# HISTORIC AND DESIGN REVIEW COMMISSION

**HDRC CASE NO:** 2022-346  
**ADDRESS:** 506 STIEREN  
**LEGAL DESCRIPTION:** NCB 2966 (STIEREN STREET REPLAT), BLOCK 1 LOT 18  
**ZONING:** RM-4, H  
**CITY COUNCIL DIST.:** 1  
**DISTRICT:** King William Historic District  
**APPLICANT:** Caroline Gado  
**OWNER:** APOLLO MAYORAL LLC  
**TYPE OF WORK:** New construction of four, multi-story structures  
**APPLICATION RECEIVED:** June 13, 2022  
**60-DAY REVIEW:** Not applicable due to City Council Emergency Orders  
**CASE MANAGER:** Rachel Rettaliata

## REQUEST:

The applicant is requesting conceptual approval to construct four residential structures on the lot addressed 506 Stieren. The proposal includes three, 3-story structures and one, 2-story structure.

**1** UNIT-1 FRONT ELEVATION- NORTH  
SCALE: 1/4" = 1'-0"

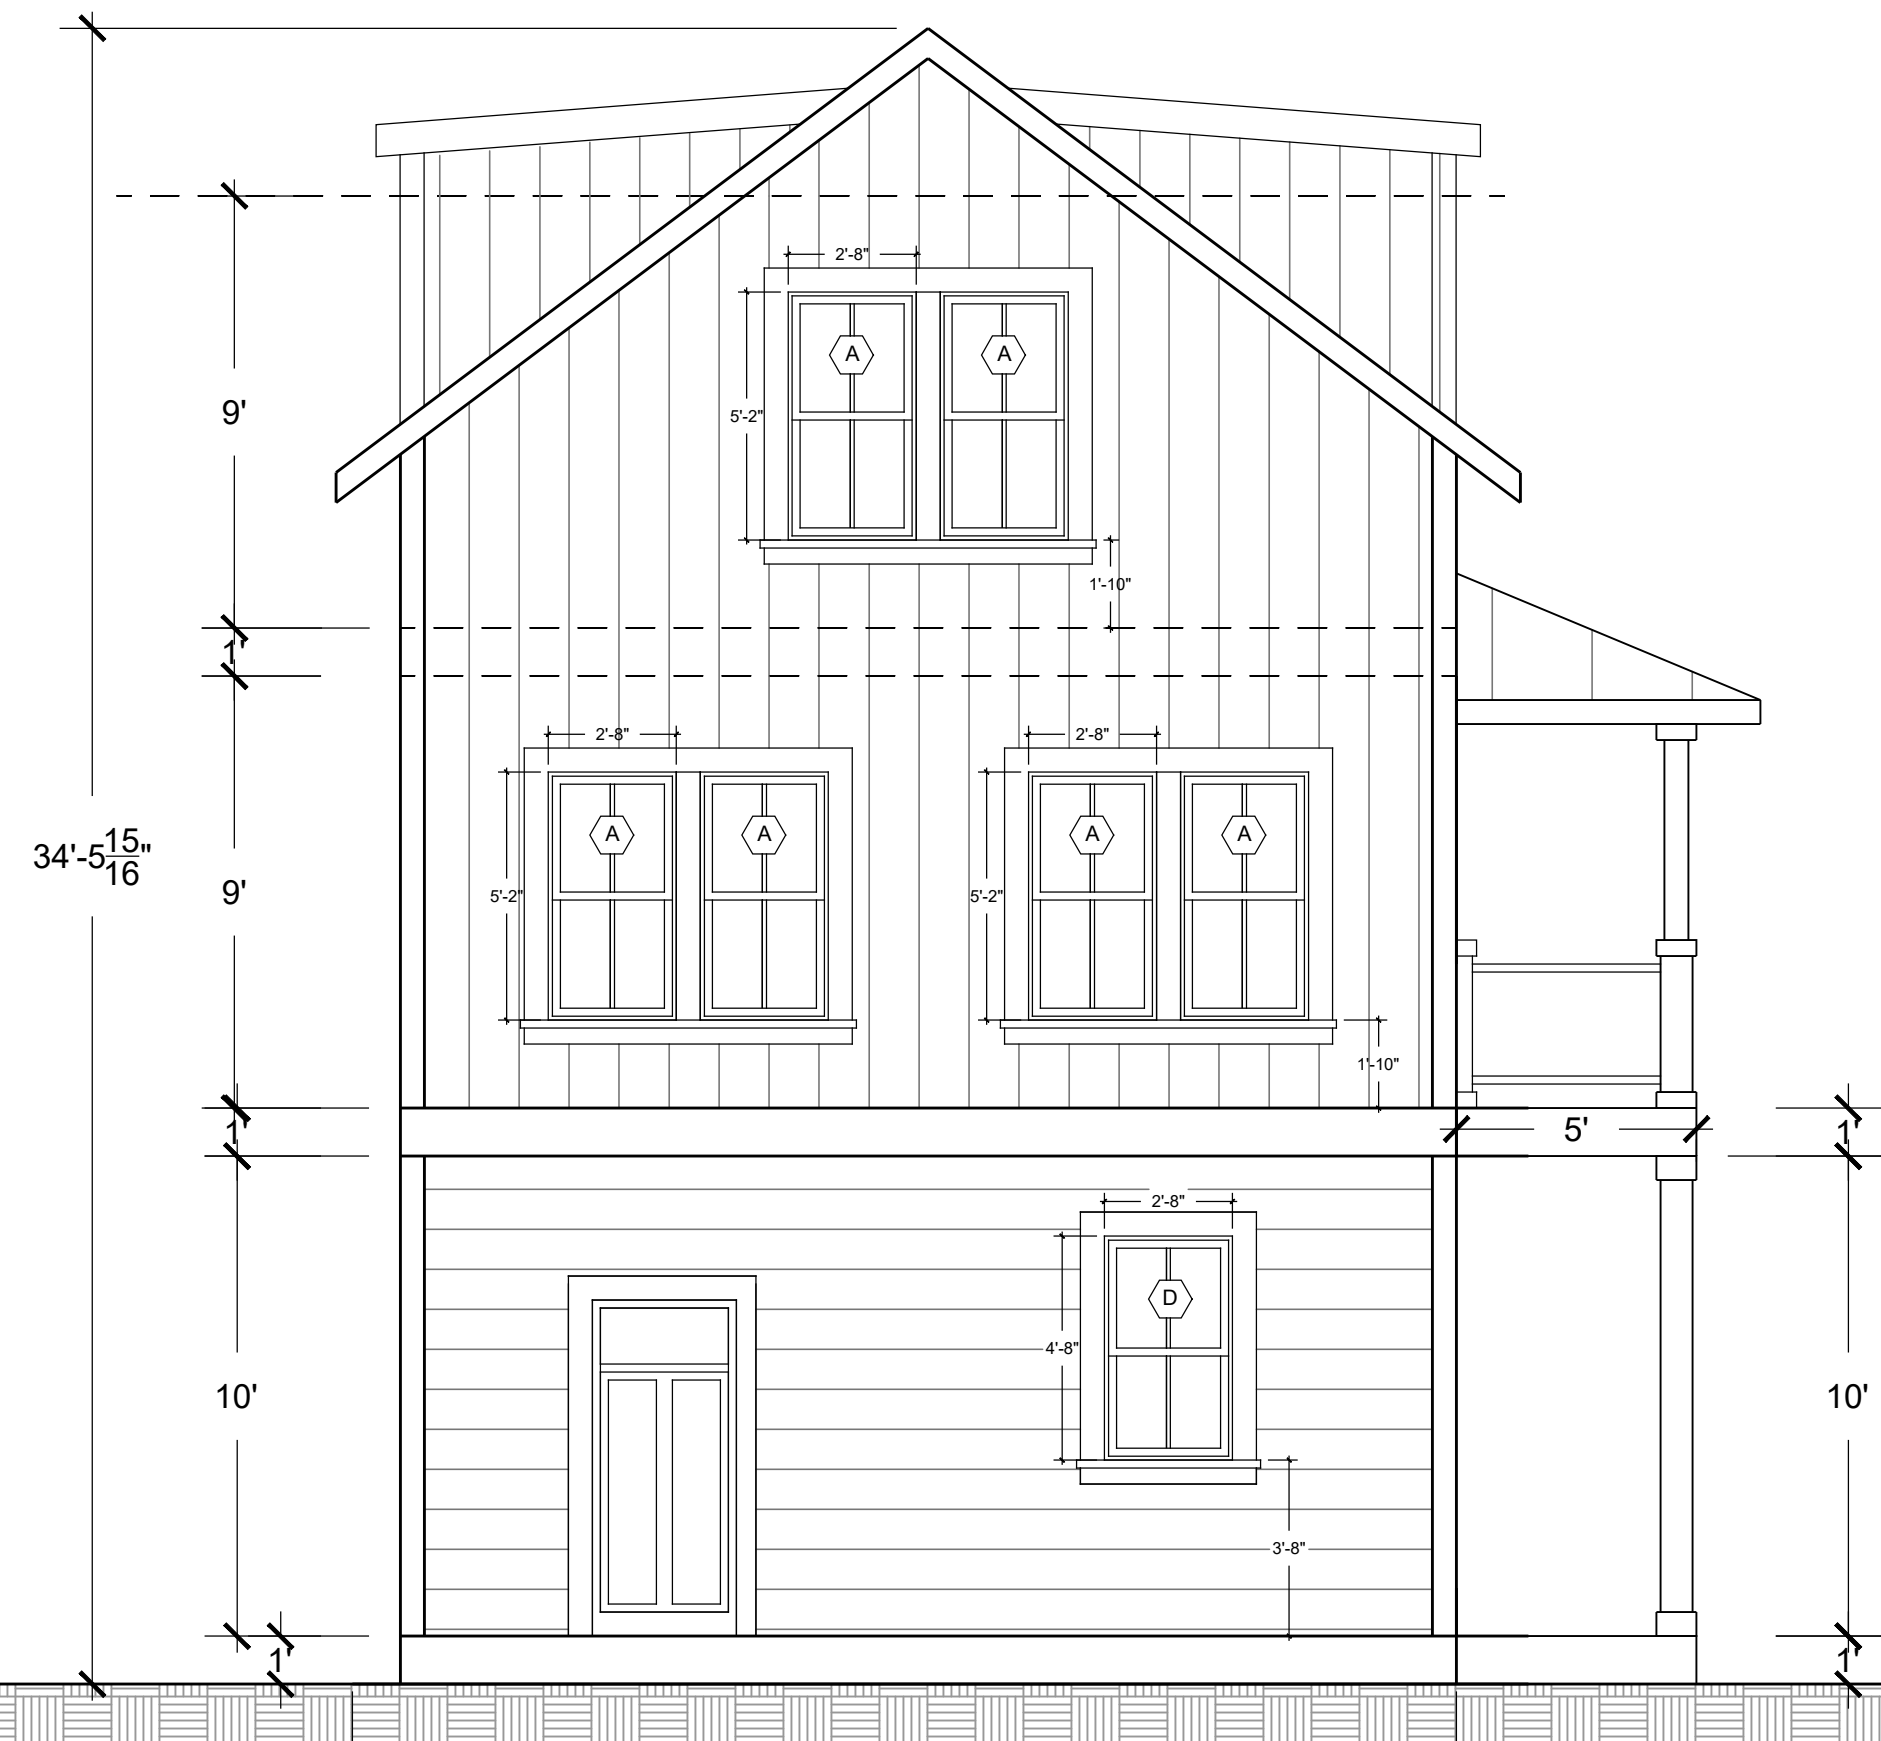
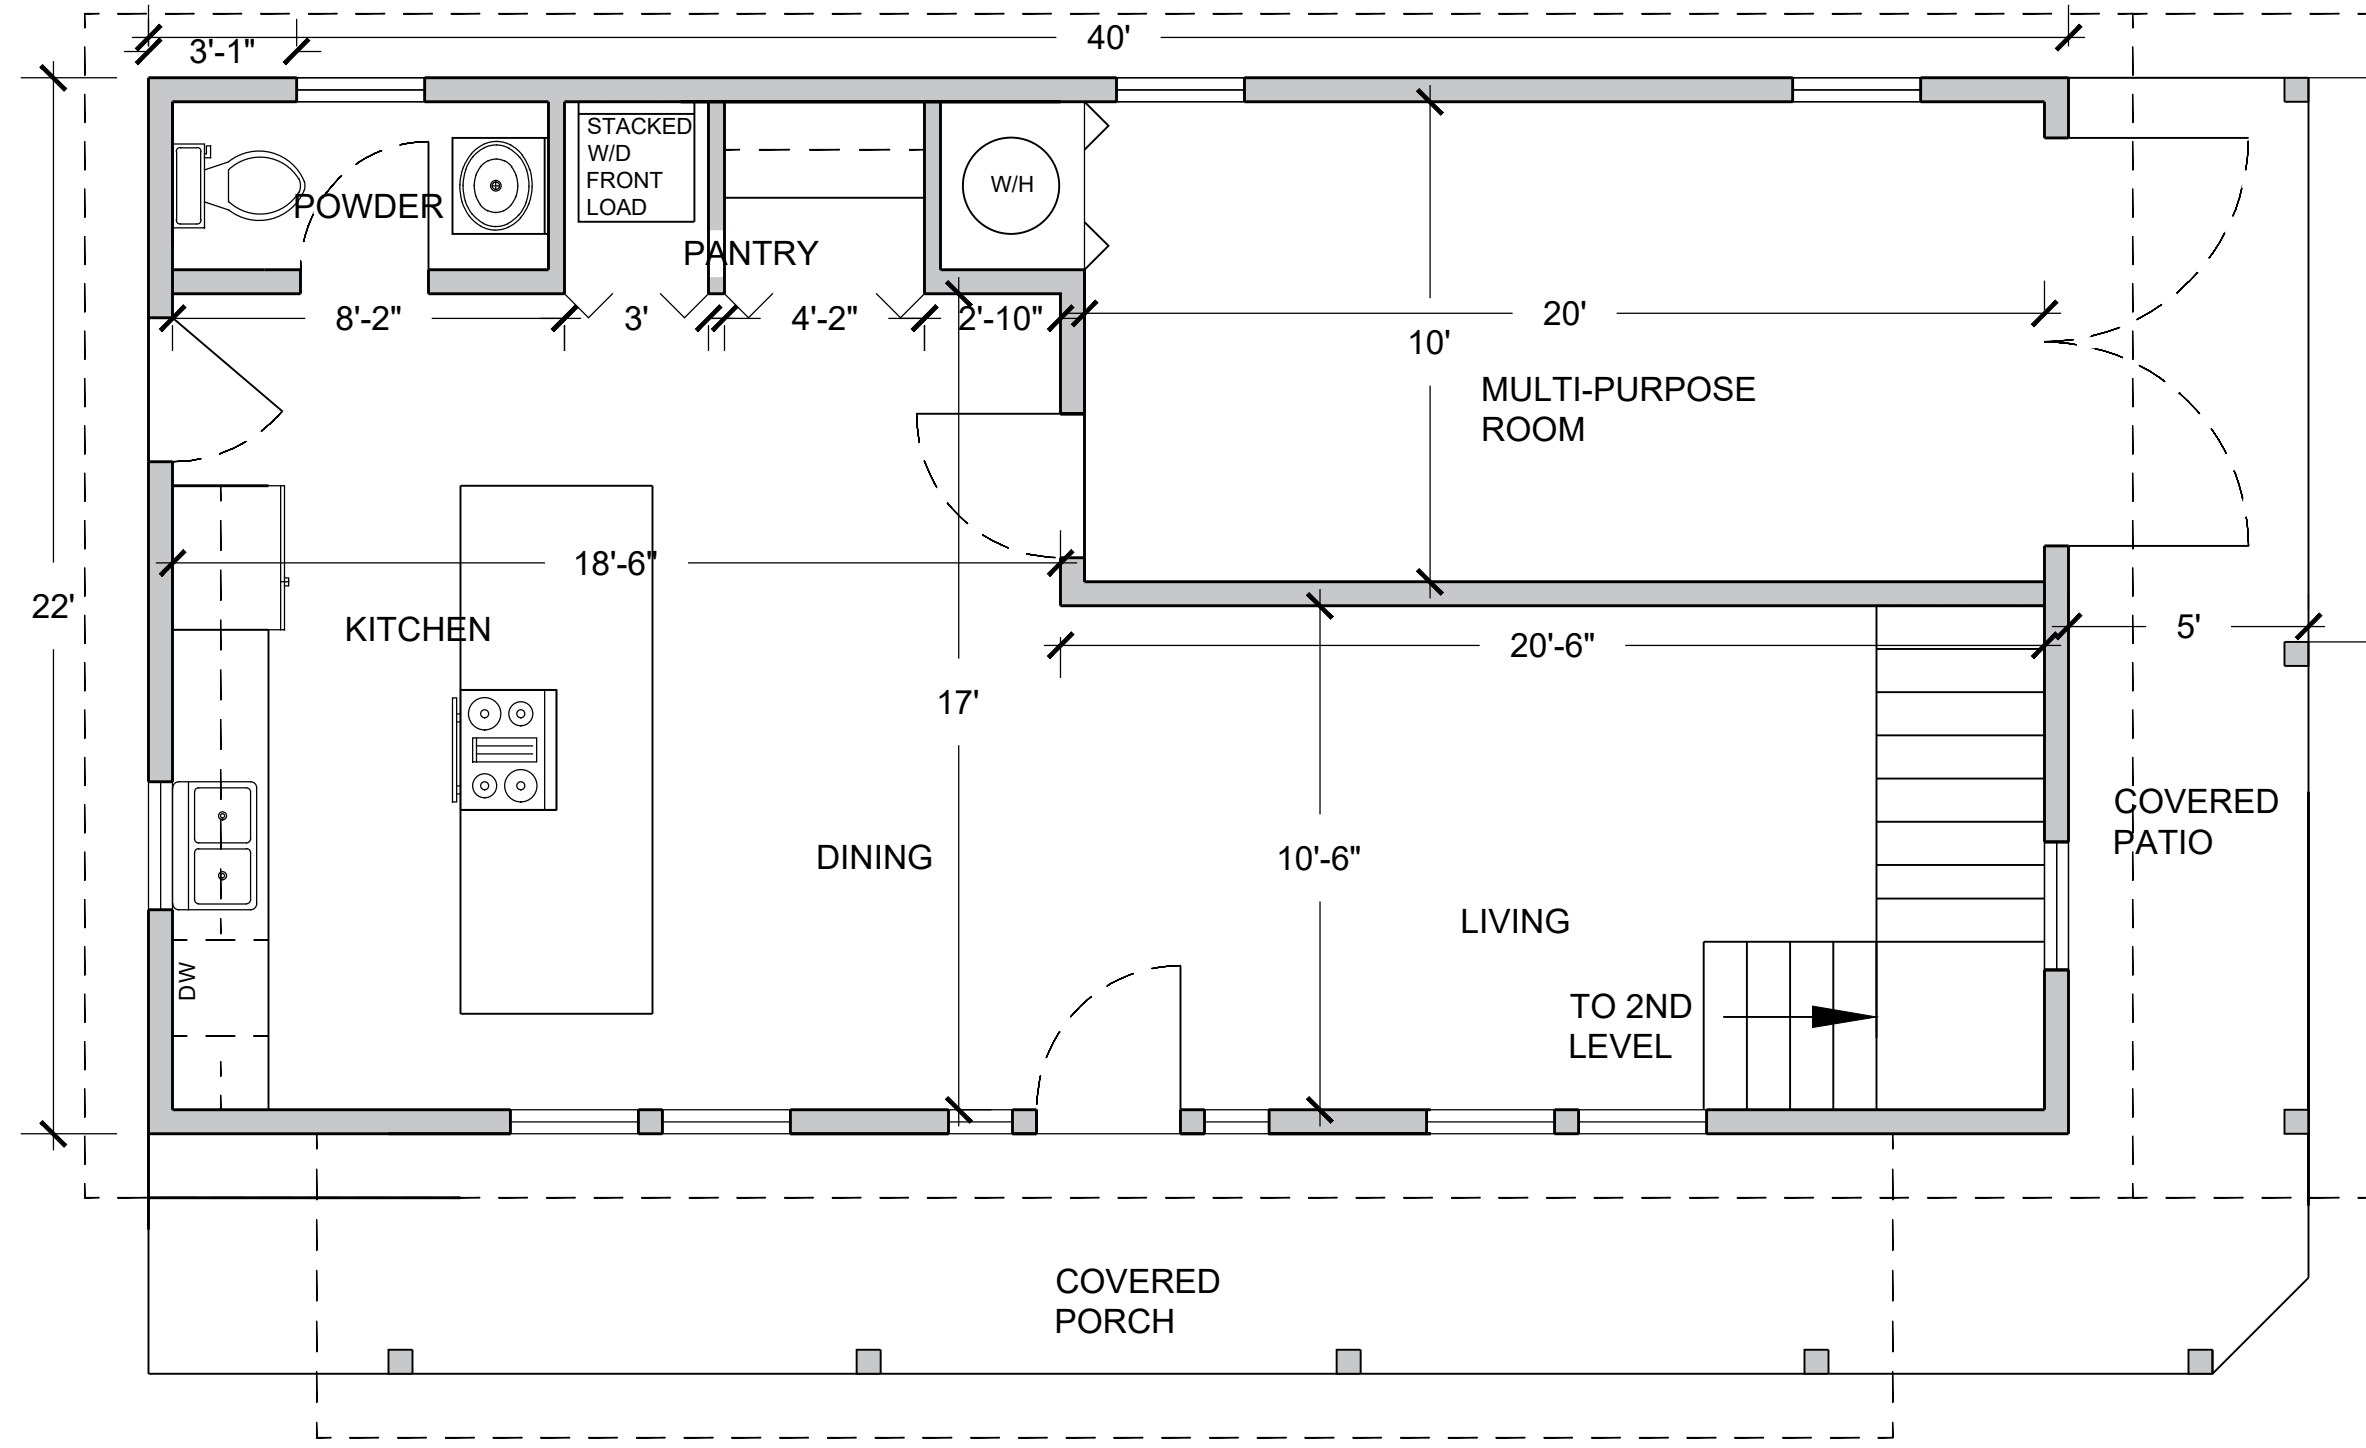
- g. **SCALE & MASSING** – The applicant has proposed to construct four detached residential structures, including three, 3-story residential structures and one, 2-story residential structure. The front building along Stieren will feature the tallest height at approximately 34'-6", with the remaining houses stepping down in height as the lot moves south from 33'-3" to 30'-9" to 27'-3". According to the Historic Design Guidelines, new construction should not exceed the height of the majority of existing structures by more than 1-story. The predominant surrounding residential context features 1-story residential and commercial structures. While there is presence of 2 and 2.5-story historic structures peppered along Cedar St, these taller structures typically feature a deeper setback than the 1-story structures. Staff does not find the proposed height consistent with the Guidelines.

- h. **ENTRANCES & PORCHES** – The applicant has proposed porch elements on all four structures. The front building along Stieren features a wraparound 2-story porch with a depth of 5 feet. The remaining interior buildings feature porches on the front facades fronting the shared interior driveway with varying depths that include recessed single-stall carports. Per the Guidelines for New Construction, The primary façade of new buildings should be in keeping with established patterns in terms of porches, entrances, orientation, and setbacks. Staff generally finds the front setback and porch design conceptually consistent, but as noted in finding f, finds the scale and massing inconsistent with the Guidelines. The height of the front building when combined with the narrow setback is also incongruous with overarching development patterns, which typically feature 1-story structures closer to the street and taller structures (2 to 2-½ stories) set further back from the street as noted in finding d.

- ii. That the applicant increases the setback of the front unit to be more consistent with the development pattern of the district as noted in findings g and j.

- iii. That the applicant reduces the height of the front structure to 2 ½-stories as noted in finding f.
- iv. That the applicant reduces the heights of all three of the rear three structures to be subordinate to the primary structure as noted in finding f.
